**FINDINGS AND RECOMMENDATION
OFFICE OF PLANNING AND ZONING
ANNE ARUNDEL COUNTY, MARYLAND**

CASE NUMBER: 2024-0193-V

REQUEST

The applicants are requesting a variance to allow a dwelling addition (carport) with less setbacks than required on property located at 1080 Broadview Drive in Annapolis.

SHEET TITLE:
SITE PLAN

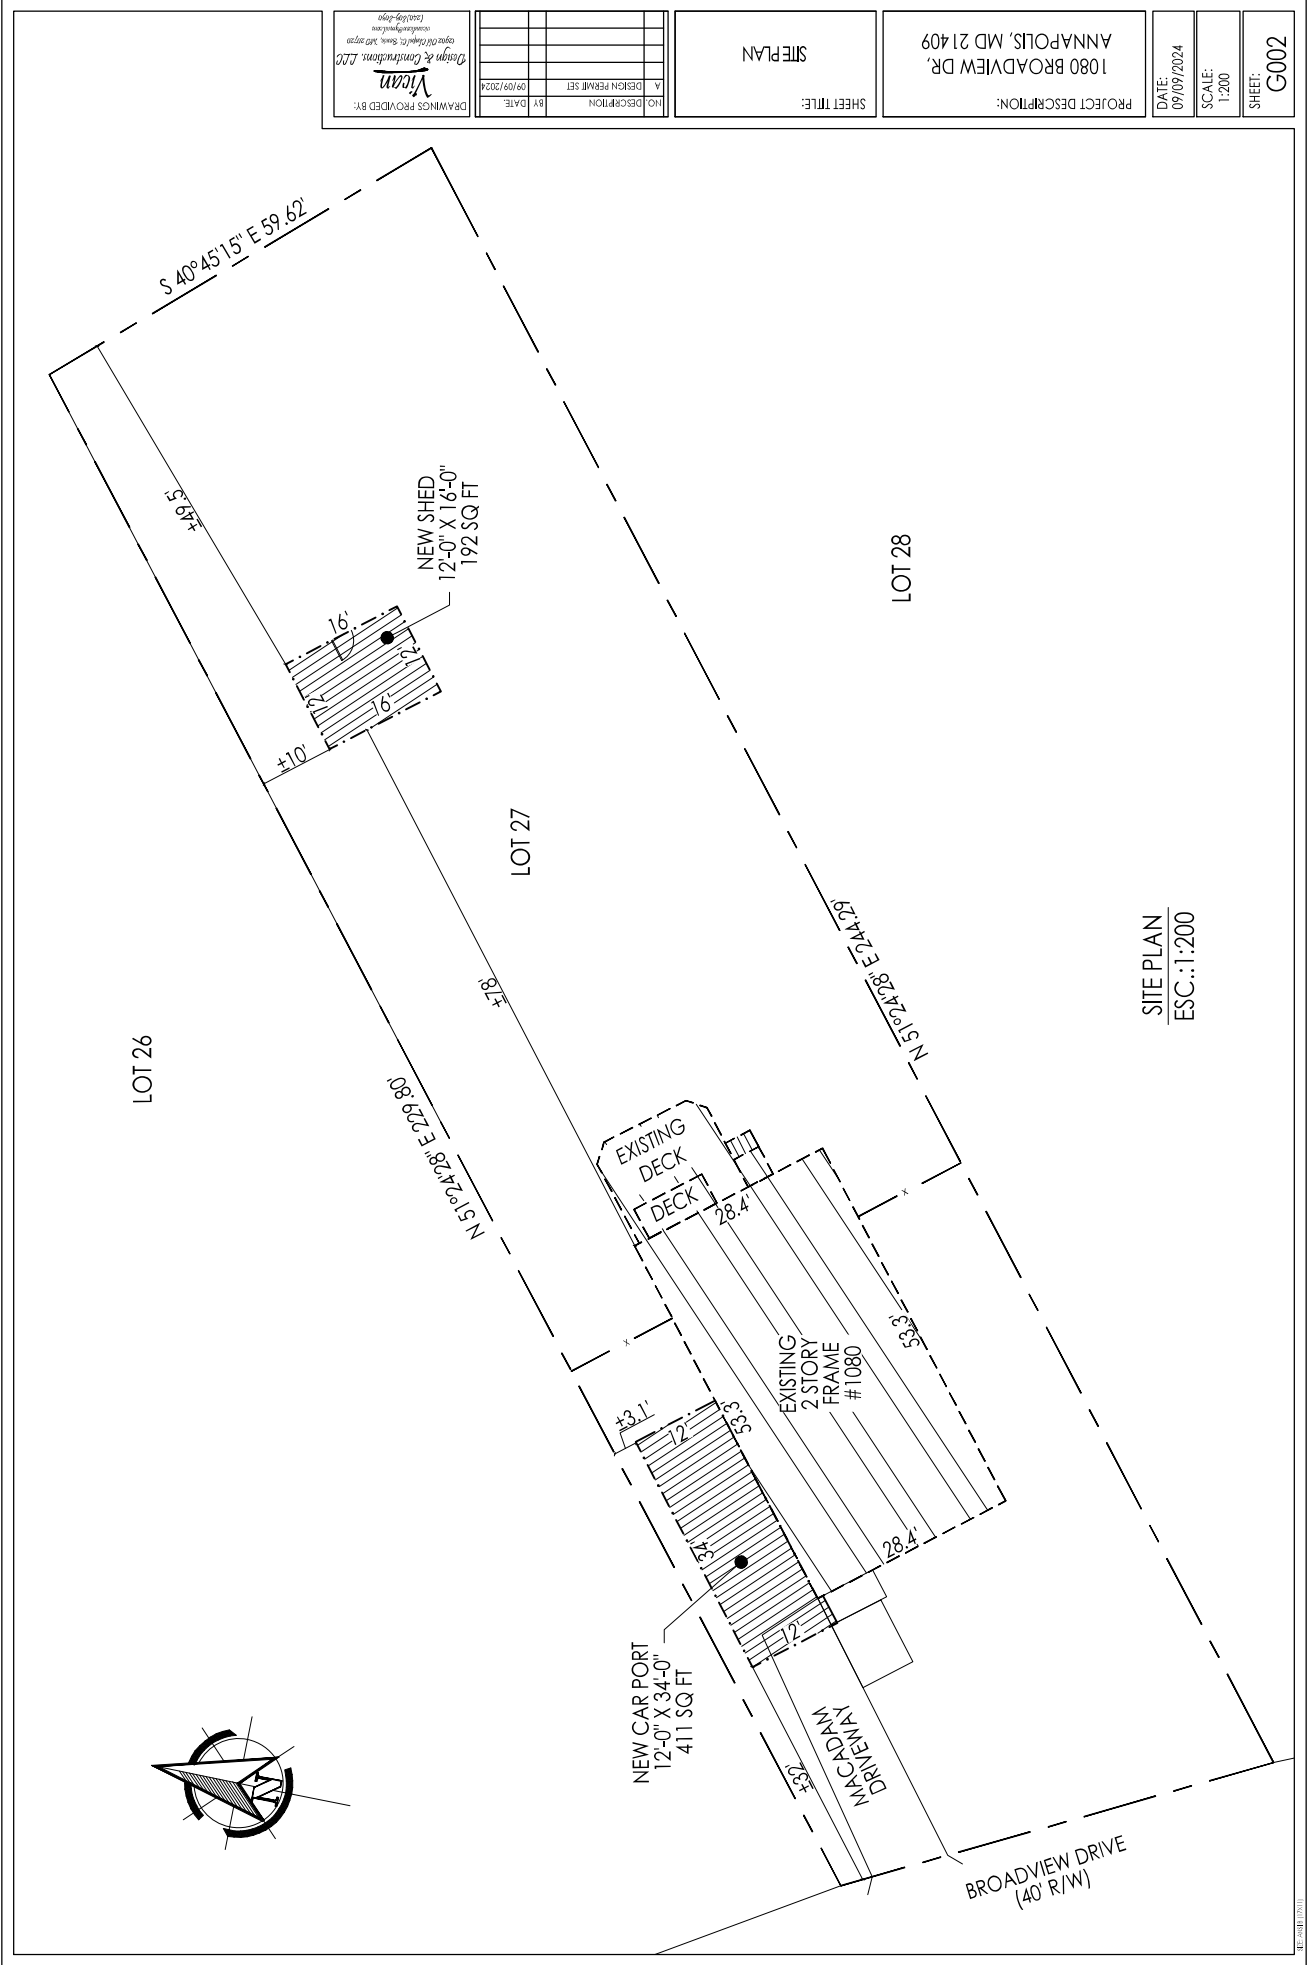
§18-4-601 of the Anne Arundel County Code requires that a principal structure in an R5 District shall be set back a minimum of seven feet from the side lot line. The proposed carport will be 3.1 feet from the northwest side lot line requiring a variance of 4 feet.

The proposed carport would be 34 feet long and located 3 feet from the side lot line. While 3 feet is enough distance for construction and maintenance of the structure entirely on the subject property, a 34-foot long structure is deeper than necessary for parking a car. There is no reason that an electric car or the charging port needs to be covered. Because the variance is unwarranted and unnecessary the variance request can not be considered to be the minimum necessary to afford relief.

With regard to the standards by which a variance may be granted as set forth under § 18-16-305 of the County Code, the Office of Planning and Zoning recommends ***denial*** of the variance requested.
